Well Name: ROSS DRAW 31
FEDERAL COM**Well Location:** T26S / R30E / SEC 31 /
SWNE /**County or Parish/State:** EDDY /
NM**Well Number:** 1**Type of Well:** CONVENTIONAL GAS
WELL**Allottee or Tribe Name:****Lease Number:** NMNM17225A**Unit or CA Name:** 1ROSS DRAW 31
FED COM**Unit or CA Number:**
NMNM106866**US Well Number:** 3001531391**Well Status:** Producing Gas Well**Operator:** XTO ENERGY
INCORPORATED

Sundry ID: 2662843**Type of Submission:** Notice of Intent**Type of Action:** Plug and Abandonment**Date Sundry Submitted:** 03/18/2022**Time Sundry Submitted:** 11:07**Date proposed operation will begin:** 04/18/2022

PLUG AND ABANDONMENT CONDITIONS OF APPROVAL

OPERATOR'S NAME:	XTO Permian Operating LLC
LEASE NO.:	NMNM17225A
WELL NAME & NO.:	Ross Draw 31 Federal Com 1
US Well Number:	3001531391
LOCATION:	Section 31, T.26 S., R.30 E., NMPM
COUNTY:	Eddy County, New Mexico
Sundry ID:	2662843
Karst:	<input type="checkbox"/> Low <input type="checkbox"/> Medium <input checked="" type="checkbox"/> High <input type="checkbox"/> Critical
Potash:	<input type="checkbox"/> Secretary <input type="checkbox"/> R111P
Special Area:	<input type="checkbox"/> Prairie Chicken <input type="checkbox

Ross Draw 31 Federal Com 001 - Current and Proposed WBD's

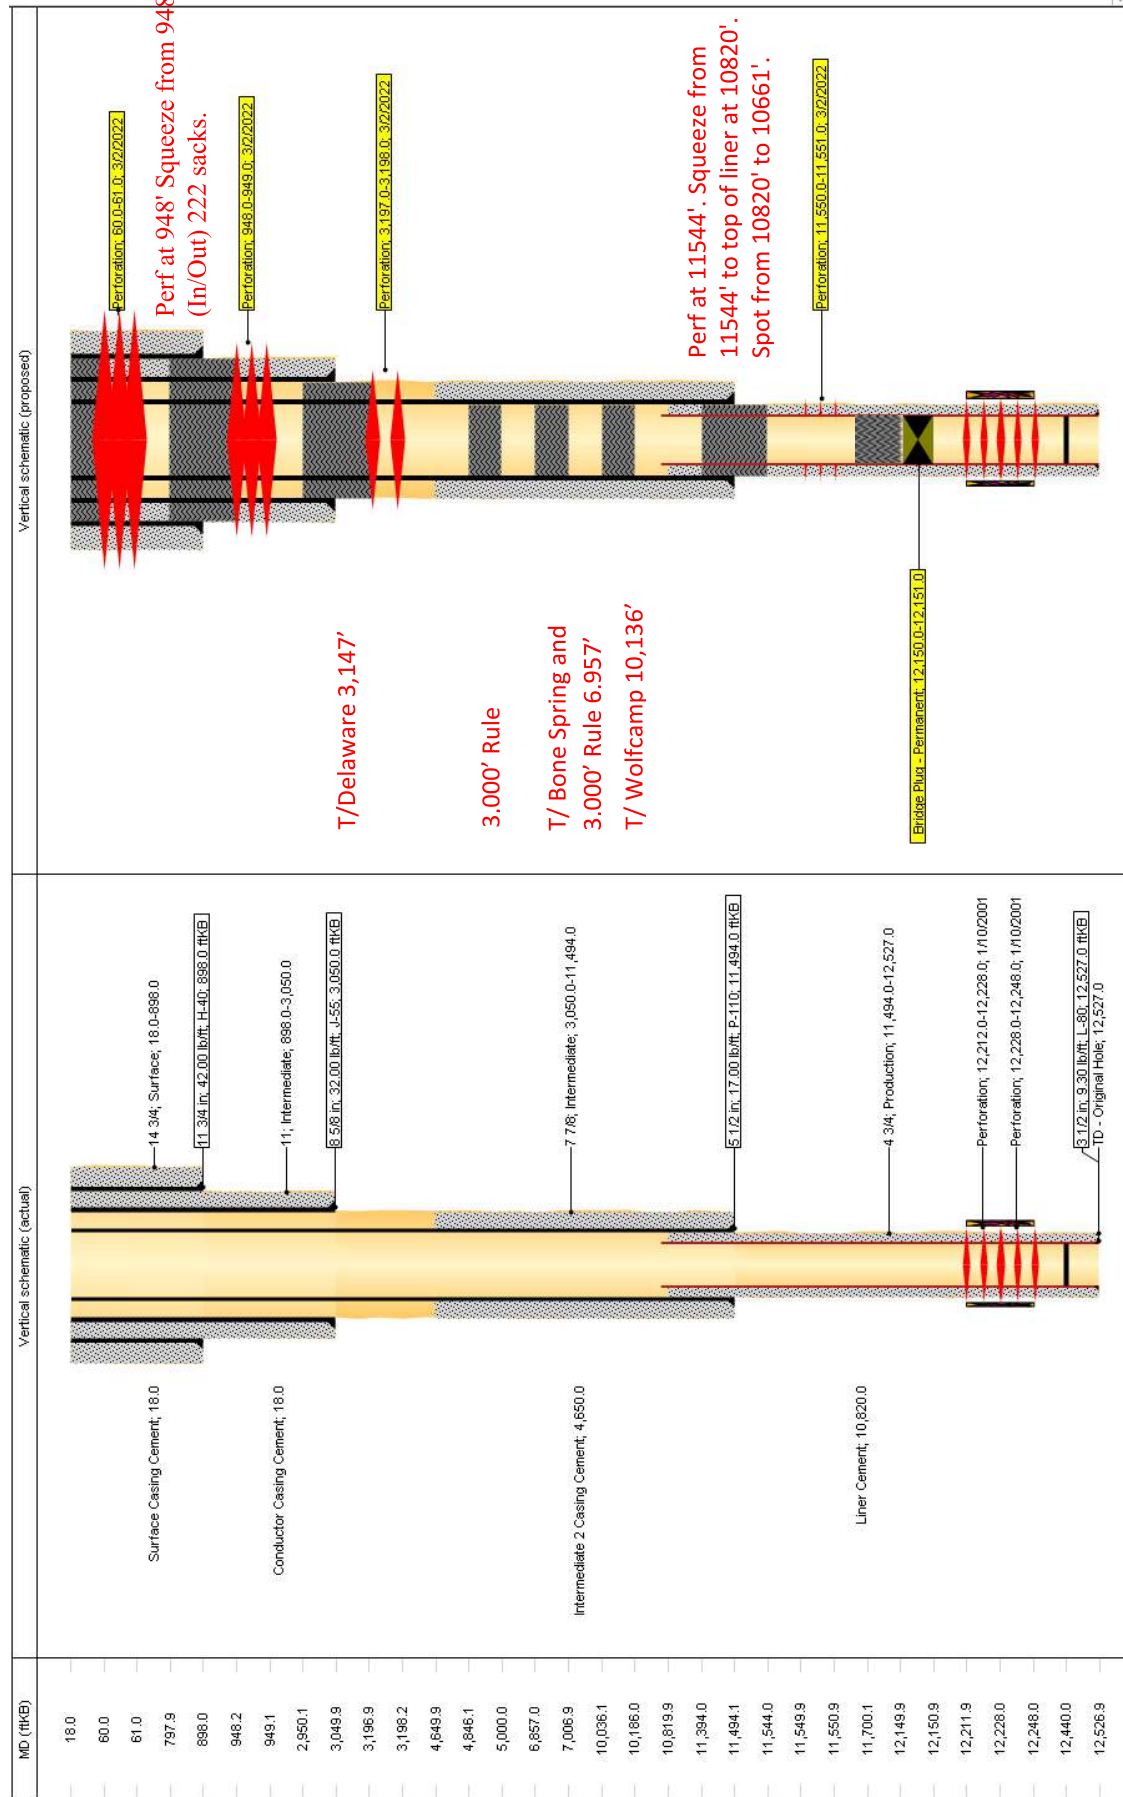
2) MIRU WL, RIH WL w/ 3.5" CIBP to 12,150'. Set CIBP and spot 25 sxs Class H cmt on top of bridge plug. Circulate 9.5# salt gel mud. Test casing to 500psi. WOC and Tag at 11,700'.

3) POOH w/ tbg. RIH WL. Perf 3.5" csg at 11550' and squeeze from 11550' to 10820', spot from 10820' to 10661', 40-110 sxs Class H cmt. WOC & Tag. (5.5" csg shoe)

4) TIH w/tbg ~~to~~ from 10,186' to 9984' and spot 25 sxs Class H cmt. (T/Wolfcamp)

5) PUH w/tbg ~~to~~ from 7,036' to 6837' and spot 25 sxs Class C cmt. (T/Bone Spring and 3,000' Rule)

6) PUH w/tbg ~~to~~ from 5,000' to 4850' and spot 25 sxs Class C cmt. (3,000' Rule)

7) POOH w/tbg. RU WL, and RIH WL. Perf 5.5" csg at 3,197' and squeeze 110 sxs from 3197' to 2969' Class C cmt. (8-5/8" csg, T/Delaware) (In/Out)

8) POOH w/tbg. RU WL, and RIH WL. Perf 5-1/2" csg at 948' and squeeze 100-222 sxs to surface Class C cmt. (11-3/4" csg shoe) (In/Out)

~~9) POOH w/tbg. RU WL, and RIH WL. Perf 5-1/2" csg at 60' and squeeze Class C cmt until returns on surface. (Surface plug)~~

- No more than 3000 feet between cement plugs in cased hole.
- Wait on Cement and Tag Top of Cement Requirement:
 1. Shoe, Top of Salt, Base of Salt, DV tool, Perforate and Squeeze, Open Perforation.
 2. Formation plug is optional if a solid base is established and confirmed.

Sundry ID		2662843				
Plug Type	Top	Bottom	Length	Tag	Sacks	Notes
Surface Plug	0.00	657.00	657.00	Tag/Verify		
Fresh Water @ 327	273.73	377.00	103.27	If solid base no		
Top of Salt @ 607	550.93	657.00	106.07	Tag/Verify		
Shoe Plug	839.02	948.00	108.98	Tag/Verify	222.00	Perf at 948'. Squeeze from 948' to surface. (In/Out) Verify at Surface.
Shoe Plug	2969.50	3100.00	130.50	Tag/Verify		
Base of Salt @ 3117	3035.83	3167.00	131.17	Tag/Verify		
Delaware @ 3147	3065.53	3197.00	131.47	If solid base no need to Tag (CIBP present and/or Mechanical Integrity Test), If Perf & Sqz then Tag, Leak Test all CIBP if no Open Perforations	110.00	Perf at 3197'. Squeeze from 3197' to 2969'. WOC and Tag. (In/Out)
Spacer @ 4950	4850.50	5000.00	149.50	If solid base no need to Tag (CIBP present and/or Mechanical Integrity Test), If Perf & Sqz then Tag, Leak Test all CIBP if no Open Perforations	25.00	Spot from 5000' to 4850'.

If solid base no need to Tag (CIBP present and/or Mechanic al Integrity Test), If Perf & Sqz then Tag, Leak Test all CIBP if no Open Perforatio ns		
Bonesprings @ 6957	6837.43	7007.00	169.57		25.00	Spot from 7036' to 6837'.
				If solid base no need to Tag (CIBP present and/or Mechanic al Integrity Test), If Perf & Sqz then Tag, Leak Test all CIBP if no Open Perforatio ns		
Wolfcamp @ 10136	9984.64	10186.00	201.36		25.00	Spot from 10186' to 9984'.
Liner Top @ 10820	10661.80	10870.00	208.20	If solid		
						Perf at 11550'. Squeeze from 11550' to 10820'. Spot from 10820' to 10661'. WOC and Tag.
Shoe Plug	11329.06	11544.00	214.94	Tag/Verify	110.00	
Perforations Plug (If No CIBP)	12055.72	12278.00	222.28	Tag/Verify		
Perforations Plug (If No CIBP)	12075.52	12298.00	222.48	Tag/Verify

If solid base no need to Tag (CIBP present and/or Mechanic al Integrity Test), If Perf & Sqz then Tag, Leak Test all CIBP if no Open Perforatio ns		
CIBP Plug	12115.00	12150.00	35.00		25.00	Set CIBP at 12150'. Leak test CIBP. Spot 25 sx.
Shoe Plug	12351.73	12577.00	225.27	Tag/Verify		Not Necessary

No more than 2000' is to be allowed between plugs in open hole, and no more than 3000' between plugs in cased hole.
Class H >7500'
Class C <7500'
Fluid used to mix the cement in R111P shall be saturated with the salts common to the section penetrated, and in suitable proportions, but not more than 3% calcium chloride by weight of cement will be considered the desired mixture whenever possible.
Critical, High, Medium, Secretary : Top of salt to surface If no salt take the deepest fresh water.
R111P: 50' from bottom of salt to surface
Class C: 1.32 ft ³ /sx
Class H: 1.06 ft ³ /sx
